Contract #: 04-0120F4Cty: SF/ALA Rte: 80 PM: 13.2/13.9File #: 69.25B**QUALITY ASSURANCE -- NON-CONFORMANCE REPORT****Location:** Changxing Island, Shanghai, PRC**Report No:** NCR-000197**Prime Contractor:** American Bridge/Fluor Enterprises, a JV**Date:** 09-Sep-2008**Submitting Contractor:** Zhenhua Port Machinery Company, Ltd (ZPMC), Changxing Island**NCR #:** ZPMC-0177**Type of problem:**

## QUALITY ASSURANCE -- NON-CONFORMANCE REPORT

## NON-CONFORMANCE REPORT TRANSMITTAL

**Subject:** NCR No. ZPMC-0177

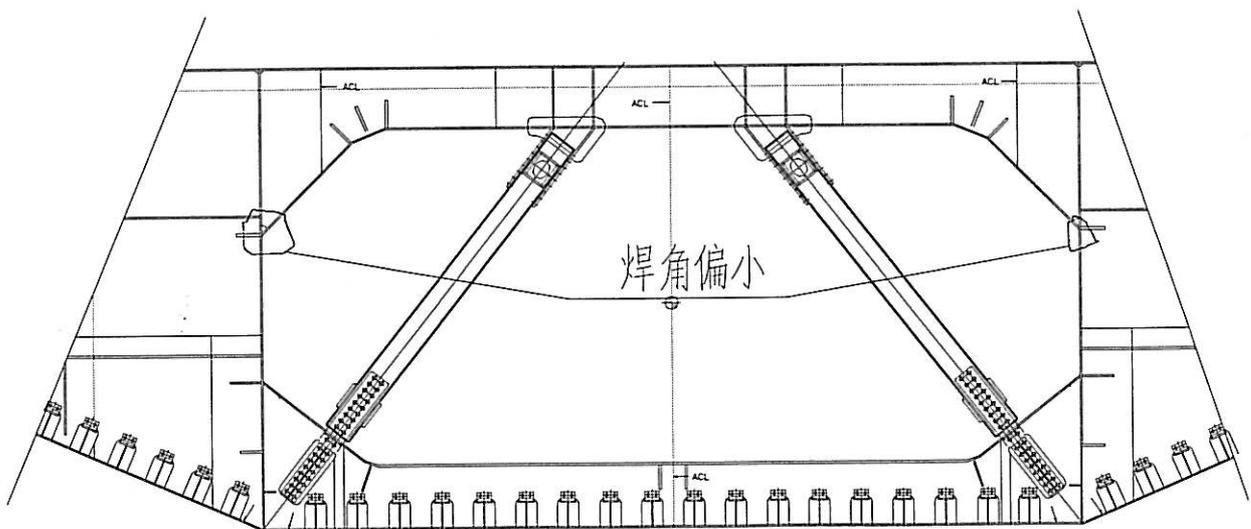
焊缝缺陷描述:

检查发现焊缝SSD17-PP021-126\SSD17A-PP021-009\SSD13-PP036-131\SSD13A-PP036-127焊角偏小2-3 mm,具体见下图。

Weld size of SSD17-PP021-126\SSD17A-PP021-009\SSD13-PP036-131\SSD13A-PP036-127 was 2-3mm shorter than technology requirement, the following shows the detail position.

1、成型焊缝后，焊缝尺寸在误差范围内，打磨结束后达不到AWS标准的要求。

1. Weld size was in the error range after welding, but it was shorter than AWS requirement after grinding.

1. 按照图纸要求对焊缝进行修补，焊后将其打磨与母材或邻近焊缝平滑过渡。

1. Continue to weld according to the shop drawing and grind the repaired weld flush with the base metal  
Or adjacent weld smoothly.
